Building Permit Application

Permit No.: **B18002802**

Description of Work: Const 32x24 ATTACHED GARAGE
ON SIDE OF EX SFD, And interior renovation
TO EX GARAGE TO make new bedroom, Full bath, sitting
room and storage. Renovate ex. laundry room
MASTER BATH, AND MASTER closet.

RE: Waiver Approval
13091 Williamfield Drive
Ellicott City, MD 21042

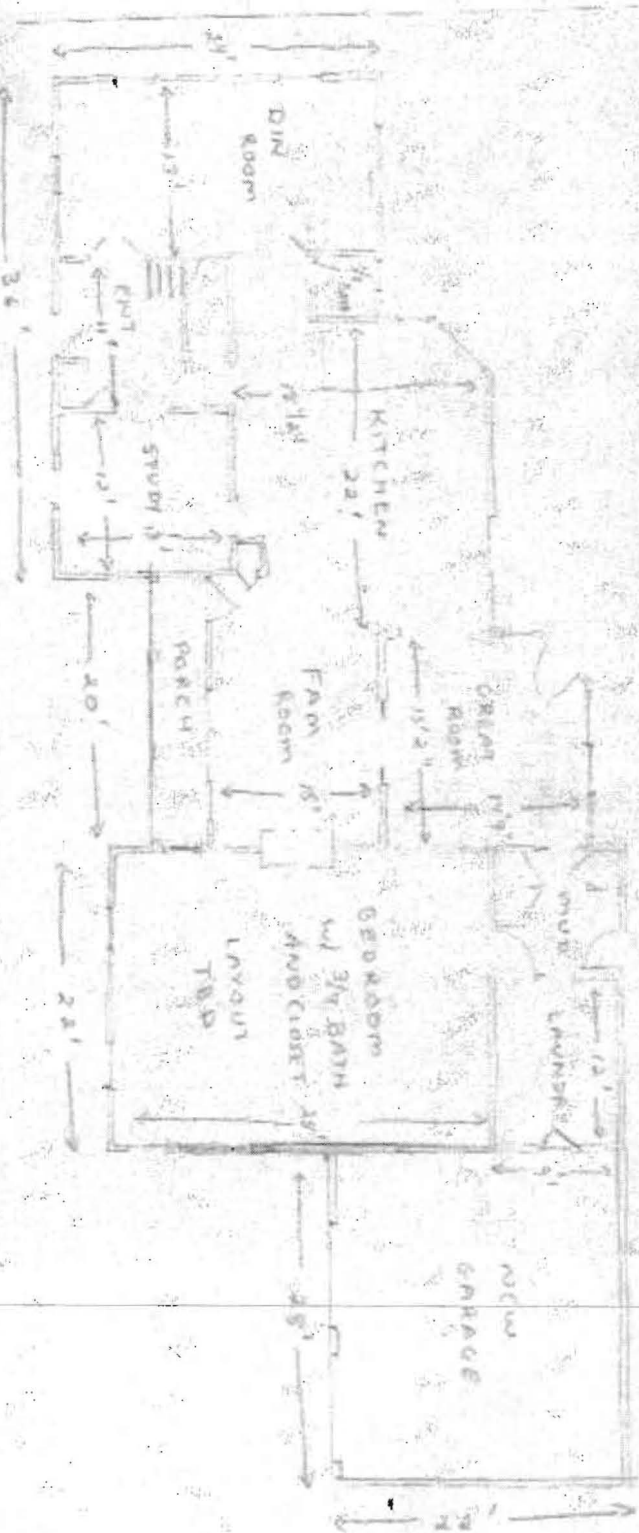
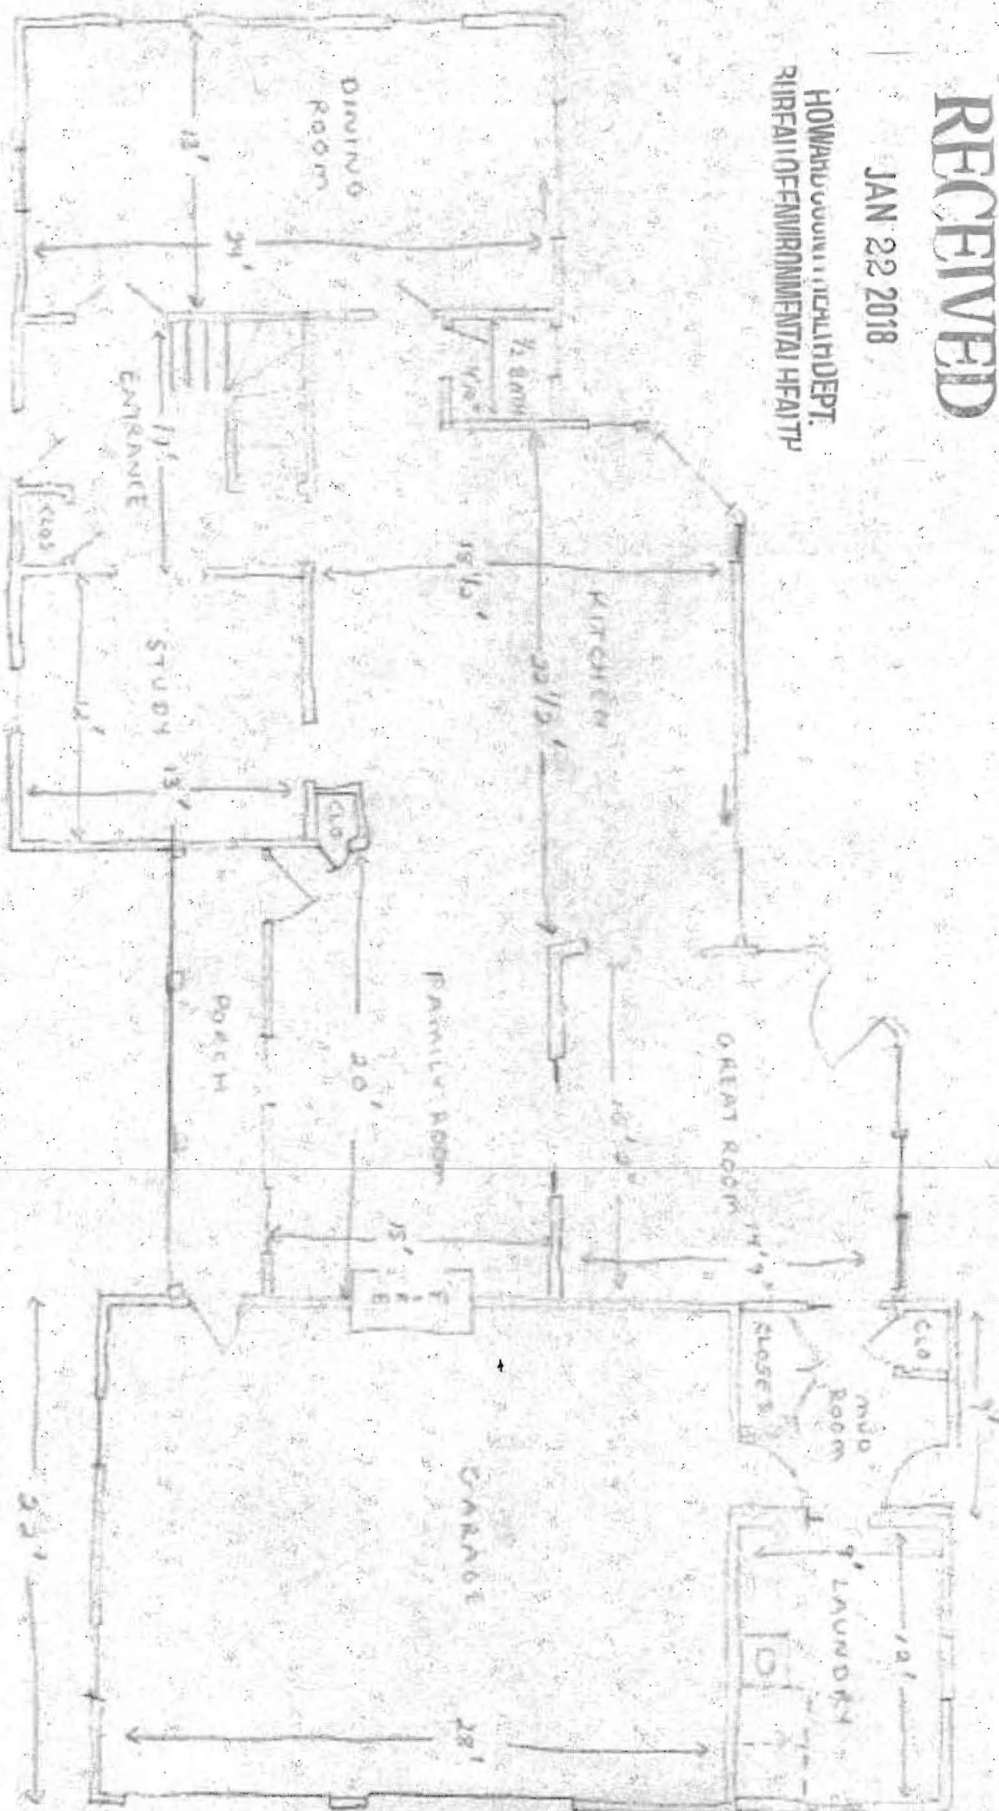
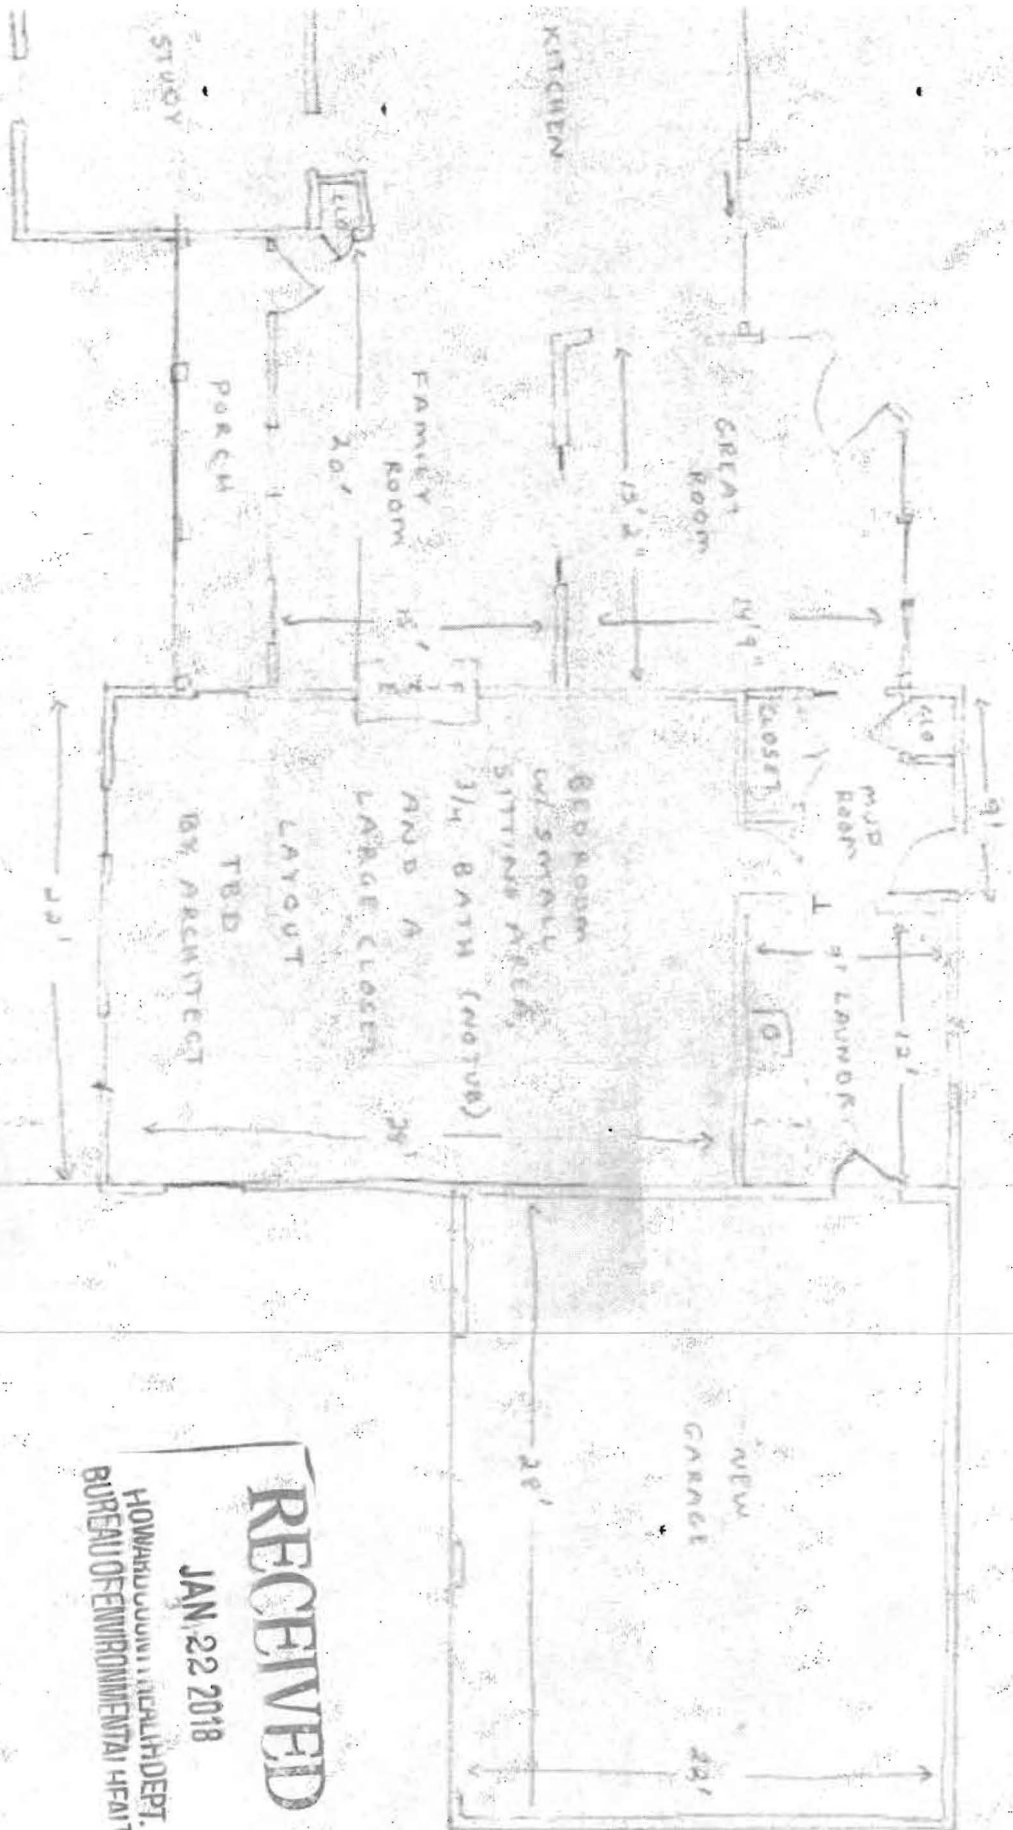
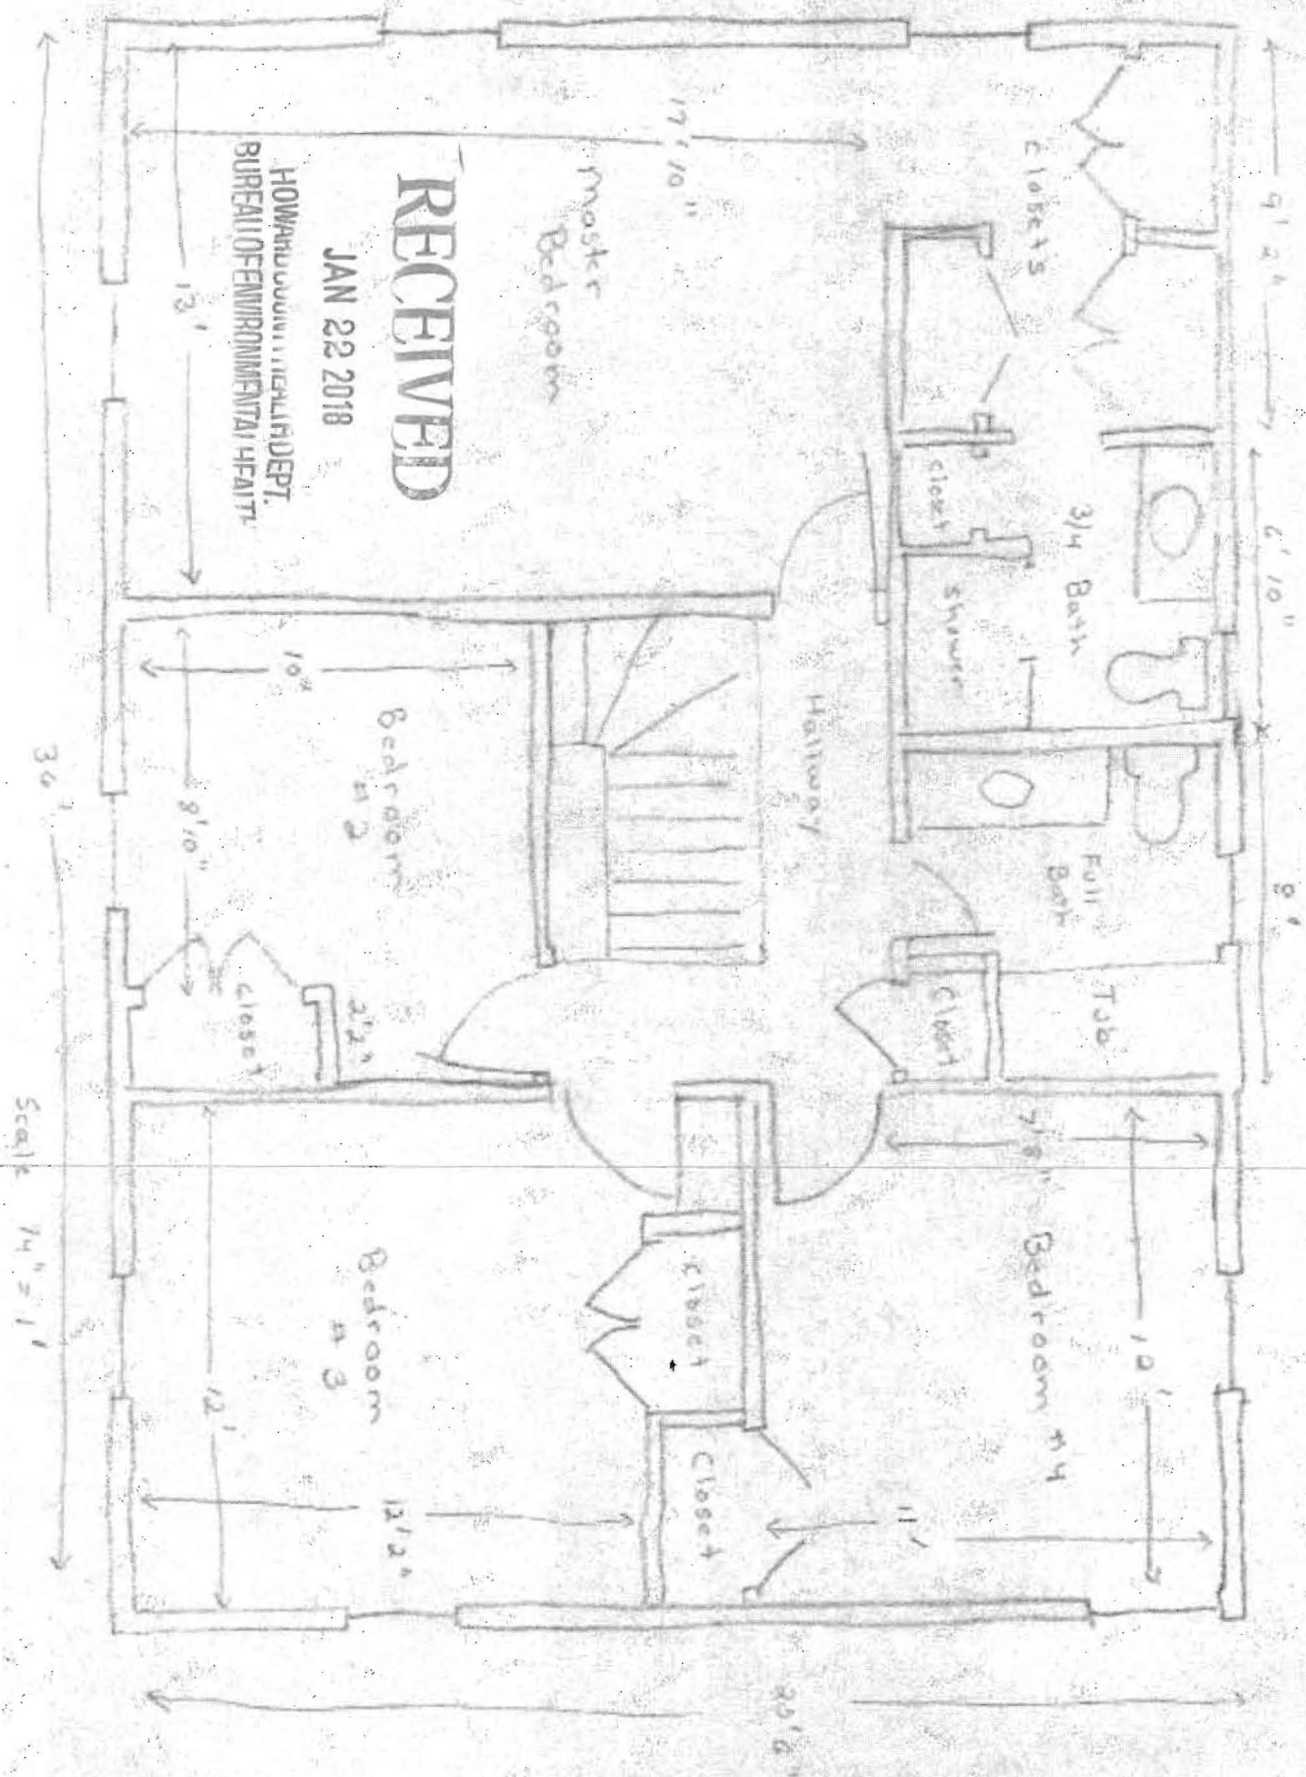
This letter is being issued in response to your waiver request dated November 8, 2018. This department has approved the waiver based on the floor plans submitted on January 22, 2018 illustrating the alterations to the floor plan to eliminate a second story bedroom and maintain the existing bedroom count of four (4). The existing on-site sewage disposal system may be maintained as is and the requirement for a percolation certification plan has been waived. Any deviations from the proposed work illustrated on the building permit site plan and the proposed floor plan will be subject to further review by this department. Any future property improvements will likely require perc testing and a revised percolation certification plan.

Hi Linda,
Mike has taken a look at the sketches and he needs clearer floor plans showing the existing house (all levels) and proposed rooms. The ones sent are hard to see and understand. You can send them straight my email and I will pass them along.

In order for us to complete our review of your waiver request letter we need to see floor plans of the existing house and proposed house. We need to see exactly how these changes are going to be installed. These floor plans do not have to be professionally done. These can be hand drawn and emailed directly to me. The list below is what we will need to see on the plans. I apologize for not mentioning this earlier as I was under the impression someone already contacted you about this. If you have any questions at all let me know.
